RE: Urban Lot Split-Preliminary Parcel Map No.:
ADM-2024-1839-PMUL
Address: 13510 Kittridge Street
Community Plan: Van Nuys – North Sherman
Oaks
Zone: R1-1 and RE11-1
Council District: 2-Krekorian

LETTER OF COMPLIANCE – Ministerial Review of SB 9 Urban Lot Split

TOPOGRAPHIC & BOUNDARY SURVEY

SITE PLAN

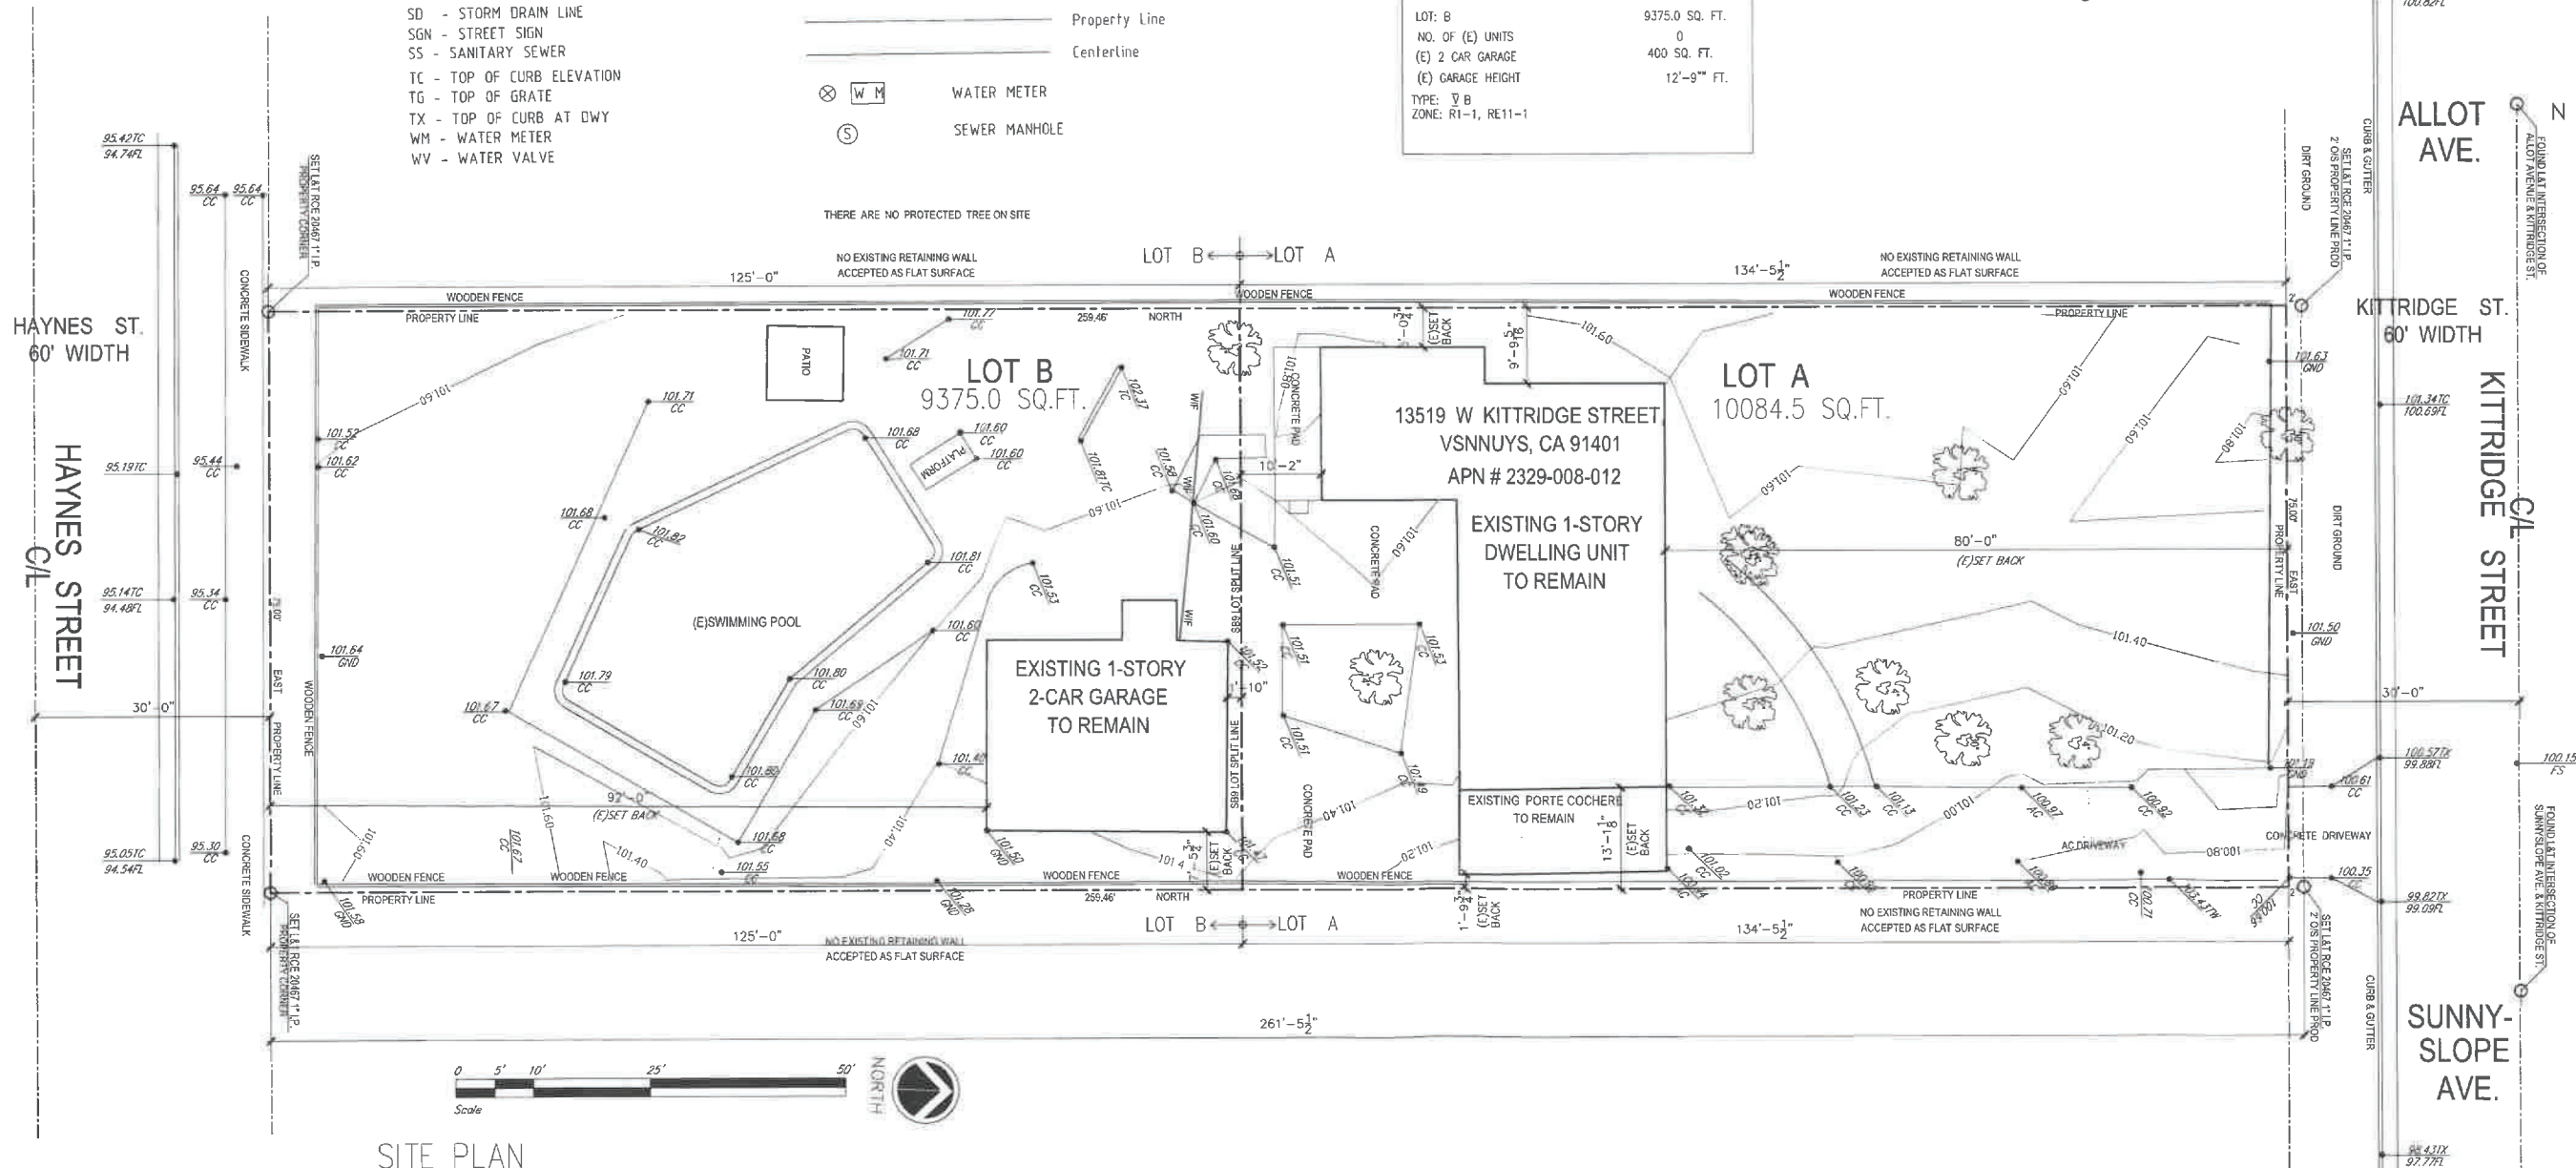
- a. The submitted plot plan is not complete. Provide a plot plan drawn to scale that accurately dimensions all: building sizes and required yards on the site.

- b. Revise the Map to match the footprints of existing garage on site with the building records 1950VN06812.
 - c. Accessory structures and uses (garage, swimming pool and patio) are not permitted to remain on the proposed Lot B without a main structure or use. Provide copies of the demolition permits and signed inspection cards to show completion of the demolition work or obtain approval from the Advisory Agency to approve for the deviations from the Zoning code.

- d. Show compliance with pool enclosure requirements per LABC Sections 3109.2 and 3109.4.
 - e. If the existing swimming pool to be removed, obtain a grading permit for the removal of the swimming pool and backfill of pool area. Provide a copy of the finalized grading permit to show completion of the work.

- f. Provide building plans for the existing garage to show compliance with current Los Angeles City Residential Code concerning exterior wall/opening protection and exit requirements with respect to the new property lines.

- i. Provide 1-hr fire-resistance exterior walls if fire separation distance is: Less than 5' [T-R302.1(1)], or Less than 3' if the building is equipped throughout with an automatic residential fire sprinkler system installed in accordance with section R313. [T-R302.1(2)]

- ii. Openings are not allowed within 3' fire separation distance. [T-R302.1(1) & T-R302.1(2)]
 - iii. Maximum 25% opening area is allowed when the fire separation distance is between 3' and 5' for building without automatic sprinkler. (T-302.1(1)).

- iv. Unlimited opening area is allowed when the fire separation distance is $\geq 3'$ for building with automatic sprinkler. (T-302.1(2))
 - v. All noncompliance issues shall be corrected, required permits shall be obtained, and the final work inspected prior to a clearance letter being issued.
